## **ADDENDUM NO: 001**

**PROJECT NAME: ARLINGTON GATEWAY MONUMENT**

**PROJECT NO.: 1256.18**

**DATE: 07/15/2022**

FILE NAME: S:\Projects\2021\Year2\105.00 Arlington Gateway Sign 3.0 (Hwy 360 & Lamar)\Drawings\E2.02.dwg LAYOUT NAME: Layout1 PRINTED: Thursday, July 14, 2022 - 10:27am USER: rlyer

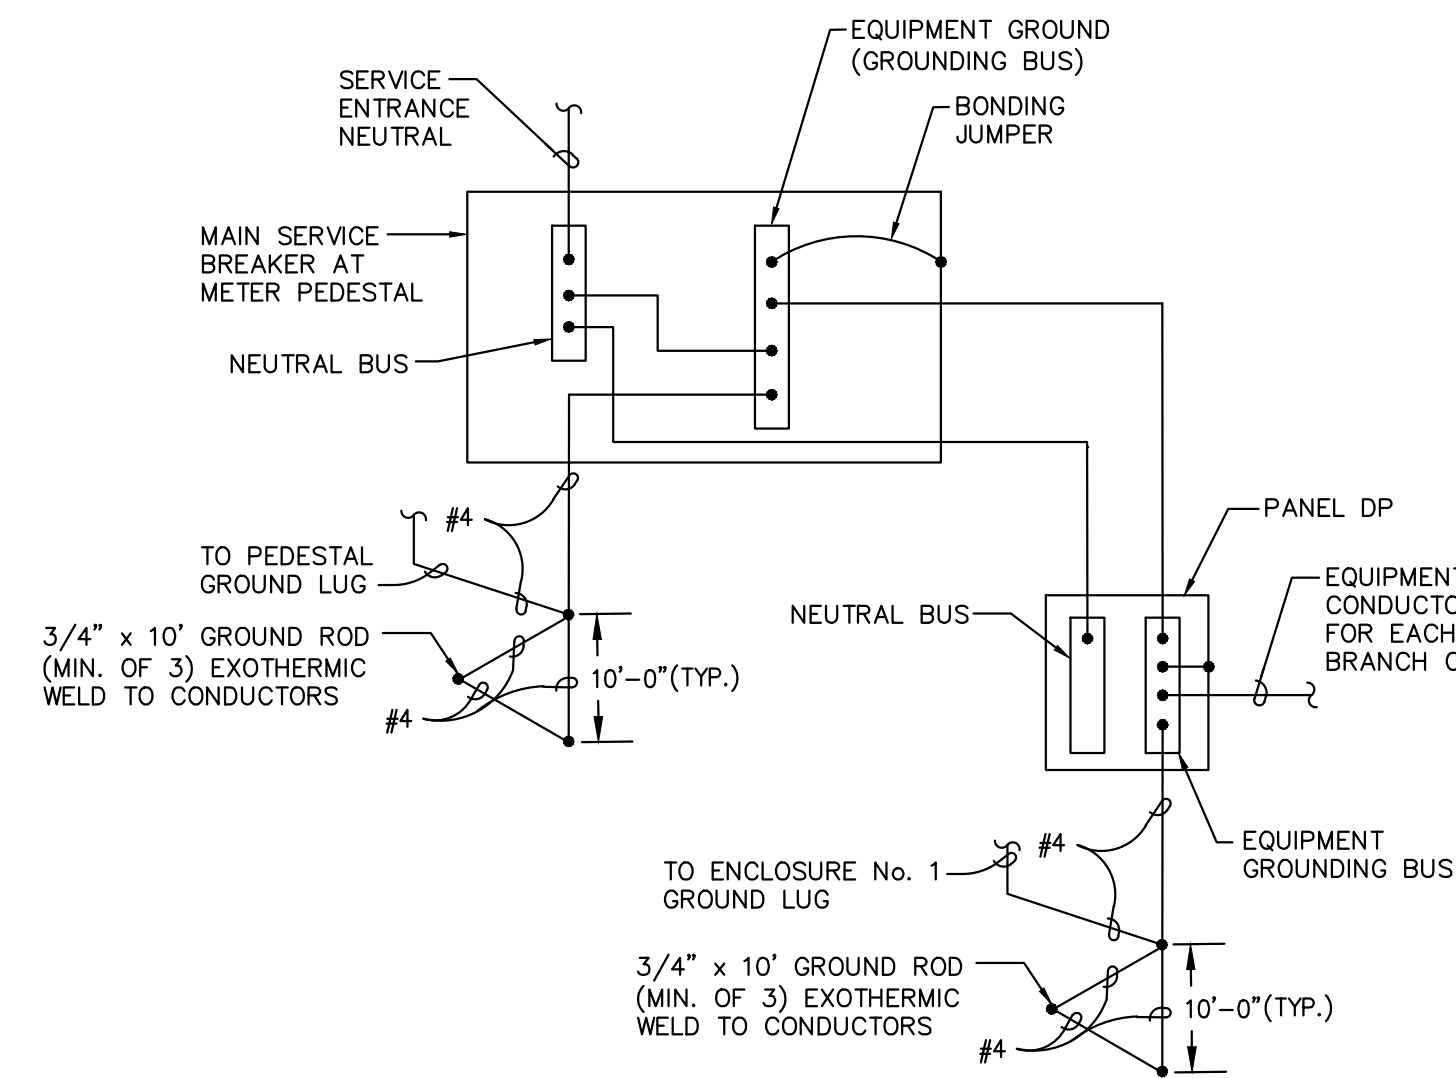
ITEM 1: SHEET 18: Delete and substitute revised drawing, dated 07/15/2022, attached and included as a part of this addendum.

A. Remove touchscreen from scope of work.

**IRRIGATION PLAN**

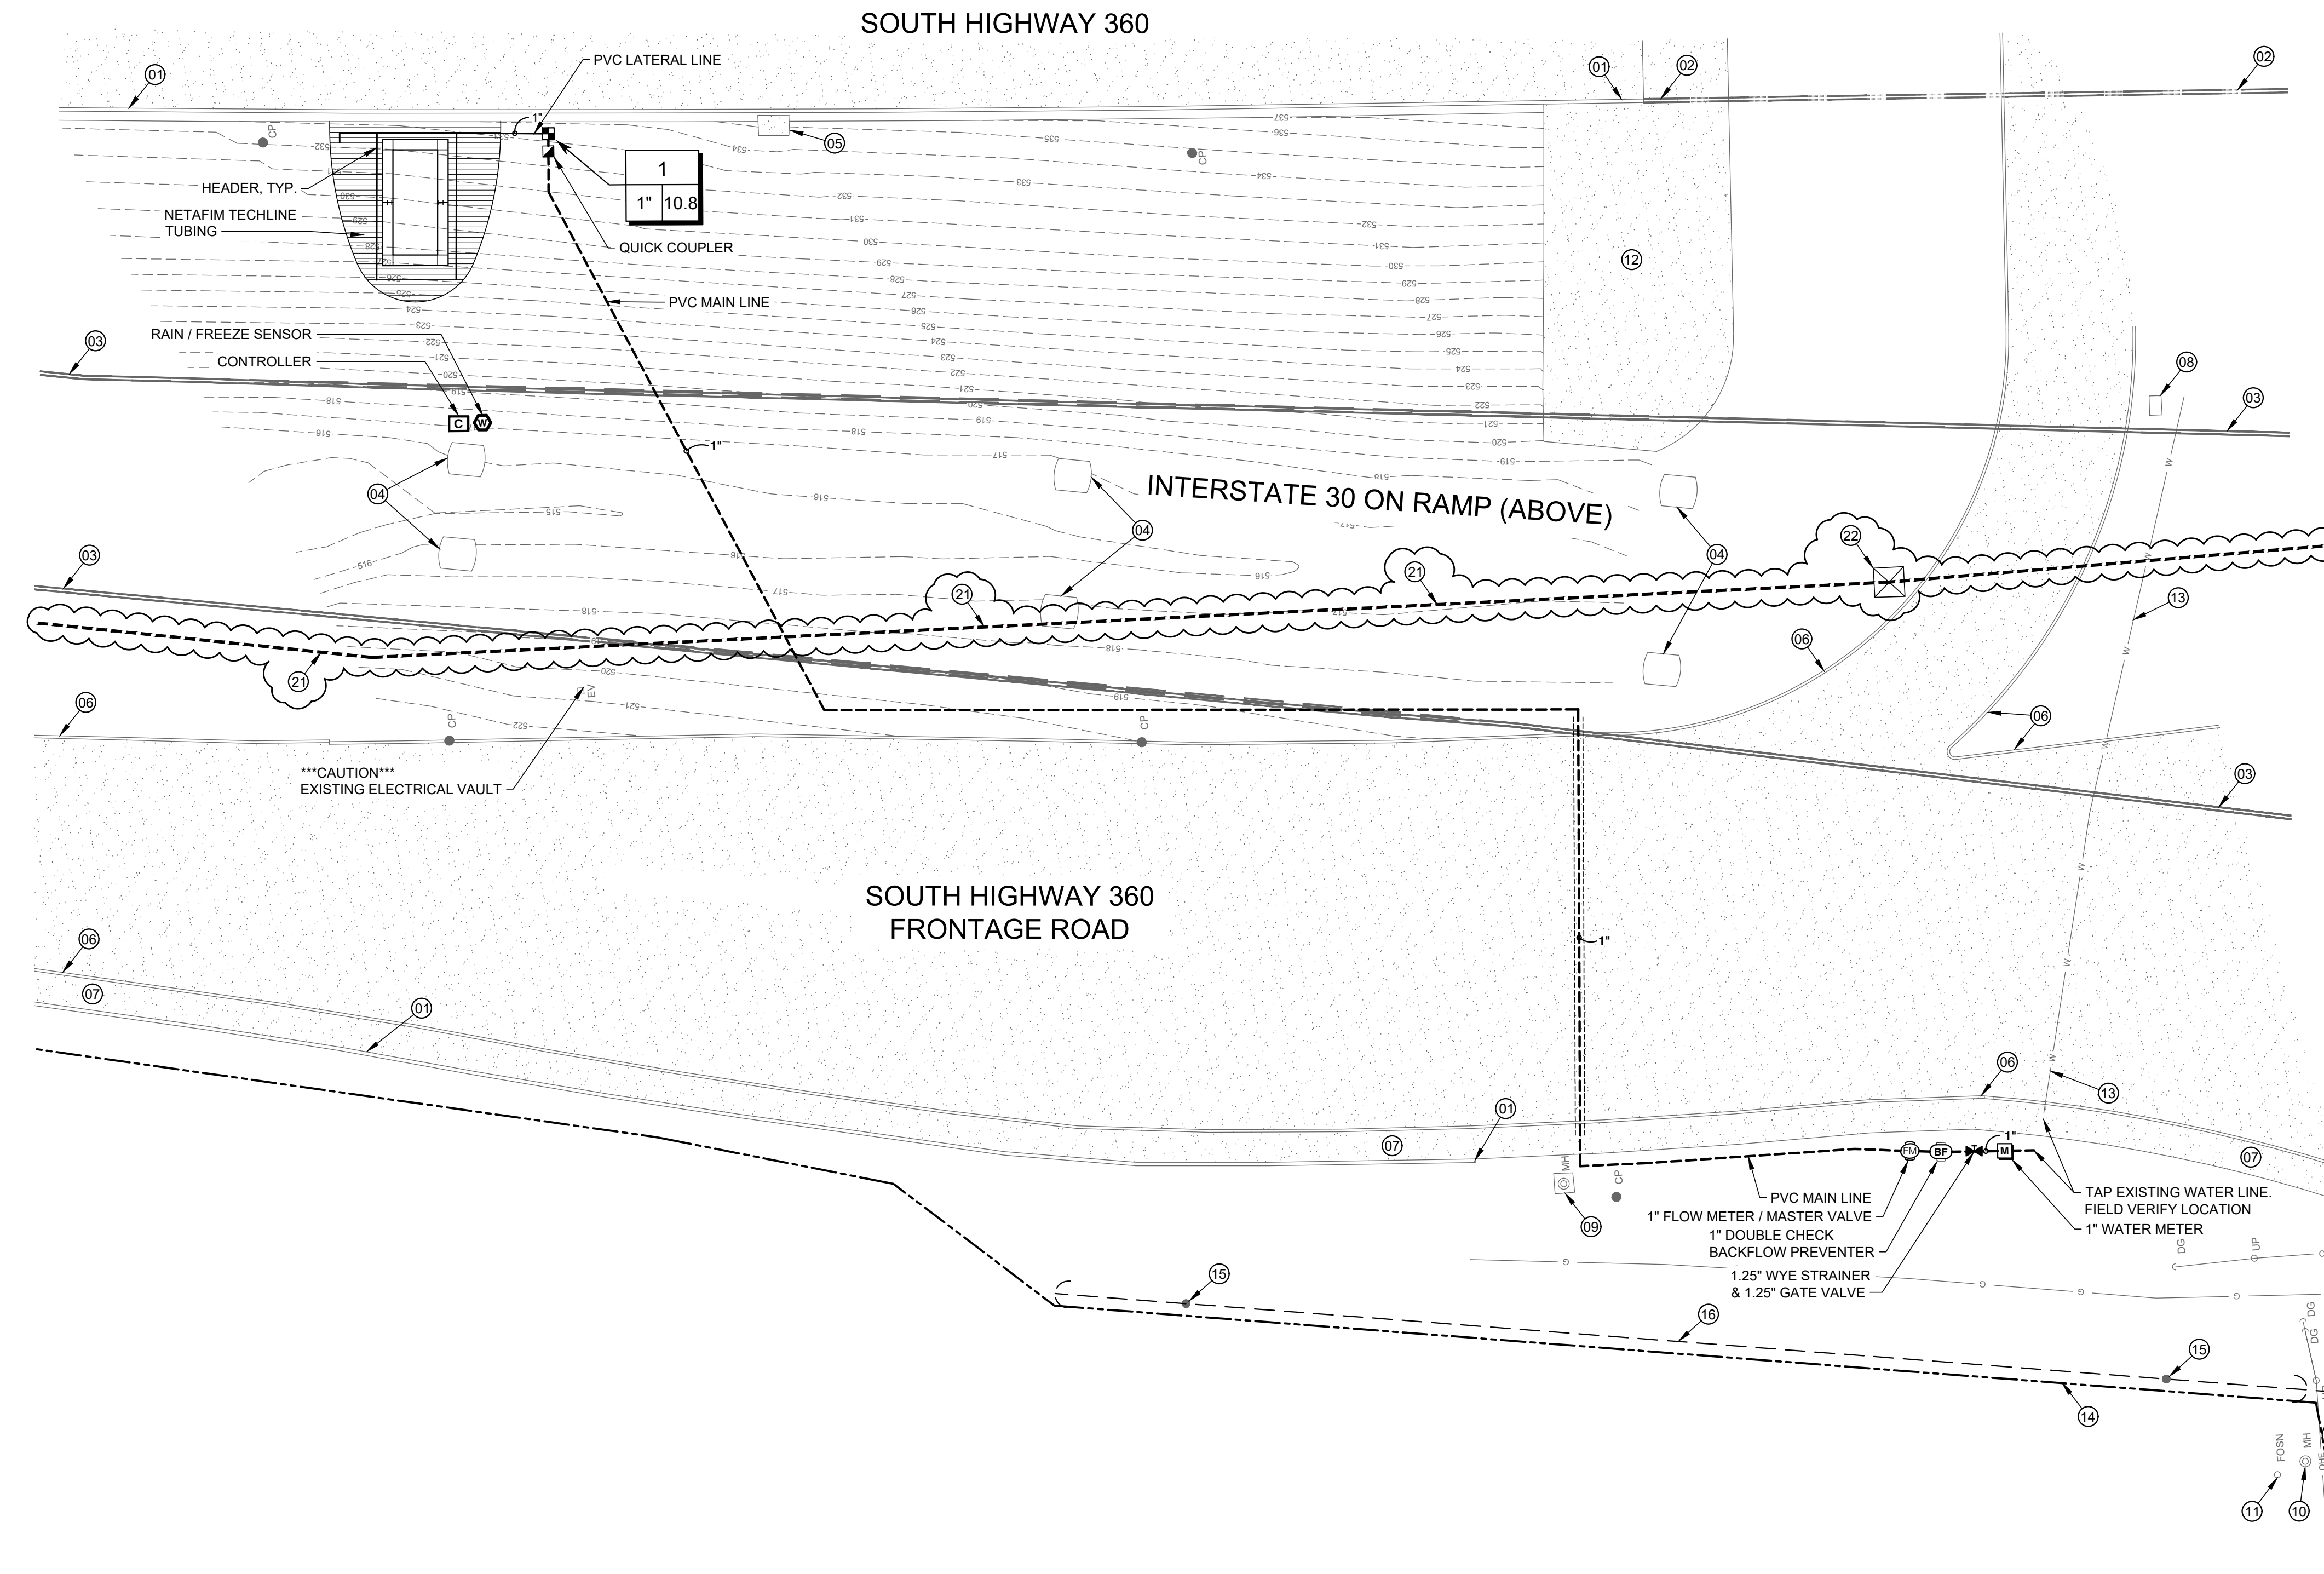
- a. Refer to revised sheet as attached to this addendum.
  - 1) Refer to attached narrative of changes provided by Yaggi Engineering.
- 6. Sheet 20 – IRRIGATION PLAN
  - a. Refer to revised sheet as attached to this addendum.
    - 1) Approximate TXDOT Fiber location added to plans per IH 30 TMS SYSTEM LAYOUT – dated 10/30/15.
    - 2) Keynote 17 added – “APPROXIMATE LOCATION OF TXDOT FIBER. CONTRACTOR TO FIELD VERIFY LOCATION AND DEPTH PRIOR TO CONSTRUCTION”
    - 3) Keynote 18 added – “APPROXIMATE LOCATION OF TXDOT AS GROUND BOX”
